NUREG-XXXX, Vol. 3

Safety Evaluation Report Related to Disposal of High-Level Radioactive Wastes in a Geologic Repository at Yucca Mountain, Nevada

Volume 3: Repository Safety After
Permanent Closure

This is Volume 3 of the NRC staff's "Safety Evaluation Report (SER) Related to Disposal of High-Level Radioactive Wastes in a Geologic Repository at Yucca Mountain, Nevada." Volume 3 presents certain results of the staff's review of DOE's Safety Analysis Report, provided in its June 3, 2008 license application, as updated by DOE in February 19, 2009, along with information provided in response to NRC staff's requests for information. In particular, SER Volume 3, documents the results of the staff's evaluation to determine if the proposed repository design will comply with the technical criteria and postclosure public health and environmental standards that apply after the proposed repository is permanently closed. (b)(5)

**Figure 6-1. Potential Flow Pathways in the EBS
(SAR Figure 2.3.7-8; DOE, 2008ab)**

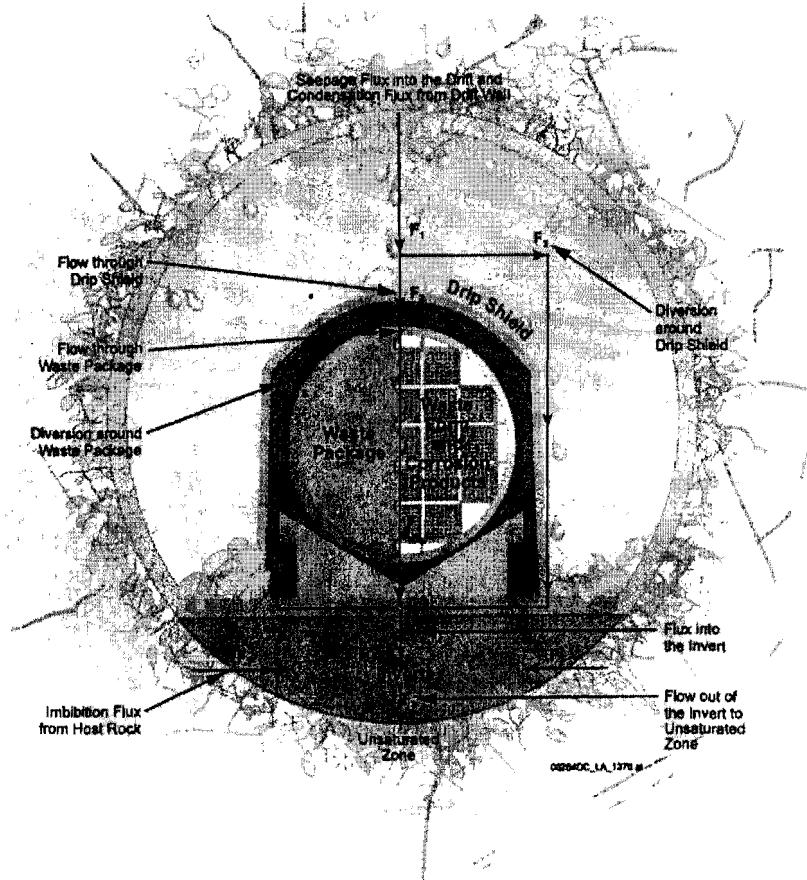
The applicant described the flow pathways and flux rates (F1–F8) in the EBS flow abstraction as follows (Figure 6-1): the F1 flow path accounts for the total dripping flux from a drift wall. The total dripping flux is the sum of the seepage flux arriving at the drift wall from above and the condensed water on drift walls (SER Section 2.2.1.3.6.3.4); these are direct inputs to the EBS flow abstraction. The F2 flow path accounts for the flux through partially failed patches of the drip shield formed by general corrosion. Localized corrosion of the drip shield is excluded from the performance assessment (SER Section 2.2.1.2.1.3). The F3 flow path accounts for the diversion of flux around the drip shield (computed as $F3 = F1 - F2$), which will drain directly into the invert. Although the diversion of flux around the drip shield is included in the construction of the EBS flow model, the applicant did not implement the flux-splitting algorithm for drip shields in TSPA simulations, because the drip shields were modeled to be either all intact or failed, as described in SNL Section 6.1.1 (2007aj). The F4 flow path accounts for the flux through patches, formed as a result of general corrosion of the outer barrier of the waste packages. Localized corrosion of the outer barrier of waste packages is not considered important (SER Section 2.2.1.3.1.3.2.5). The F5 flow path accounts for the diversion of flux around waste packages (computed as $F5 = F3 - F4$), which will drain directly into the invert. The F6 flow path is the total flux entering the invert (computed as $F6 = F4 + F3 + F5$). The F7 flow path accounts for the imbibition flux from the host rock matrix into the invert and is a direct input to the EBS Flow abstraction. The F8 flow path is the total flux from the invert to the unsaturated zone (computed as $F8 = F6 + F7$). Thus, the magnitude of fluxes in the EBS is determined by the flux rates at the drift wall, flow exchanges between the invert and the surrounding unsaturated fractured domain, and the size of corrosion patches on the drip shield and waste packages, which are externally calculated. The rest of the fluxes in the EBS are computed on the basis of the mass-conserving, flux-splitting algorithm.

However, as shown in Figure 6-1, this diverted flux around the failed waste package enters into the invert and is used to calculate F6, which determines the advective transport of radionuclides and colloids in the invert domain of the EBS radionuclide transport abstraction.
